VILLAGE OF MONROE

Special Meeting Minutes

December 15, 2025

Village of Monroe Planning Board Review

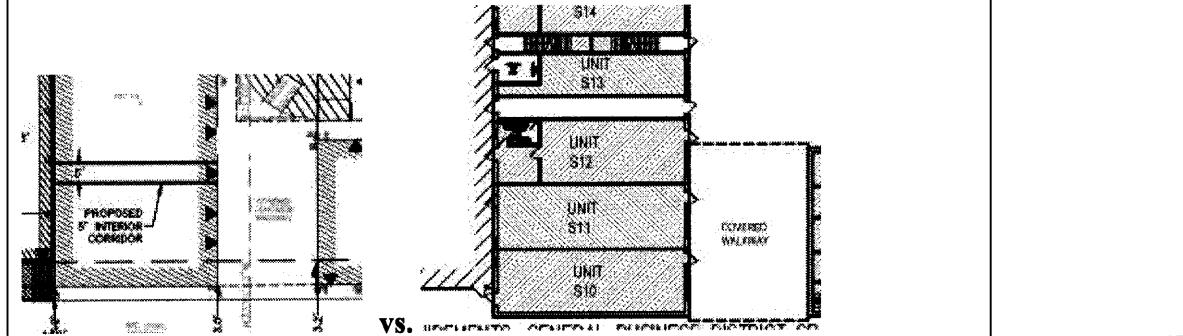
13. Site plan and subdivision layout are different with respect to the five foot corridor.

Diagram as shown on site plan:

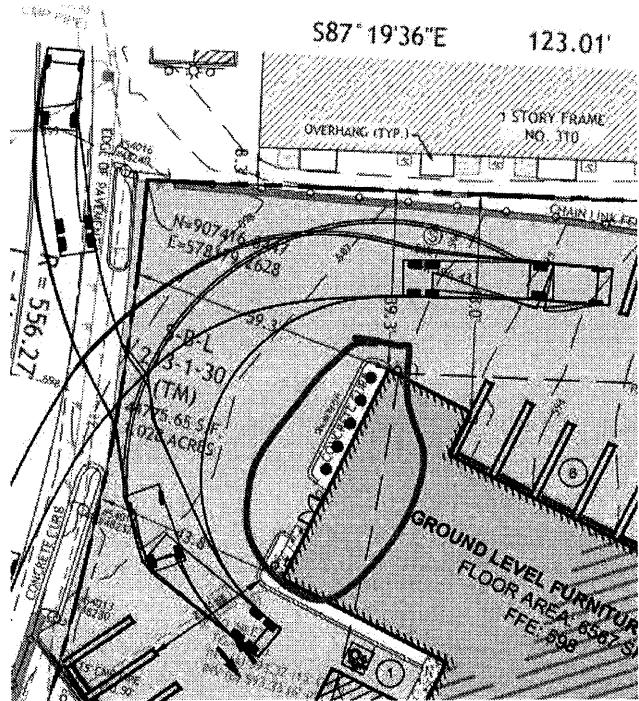
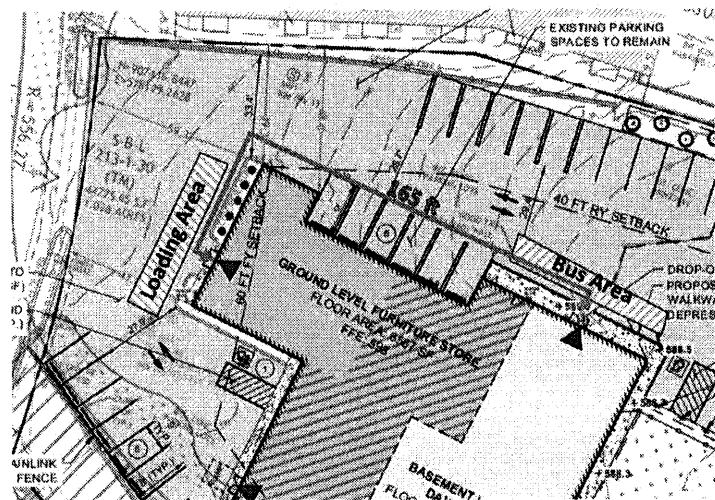
Diagram as shown on memorandum of Creighton Manning dated June 25, 2025
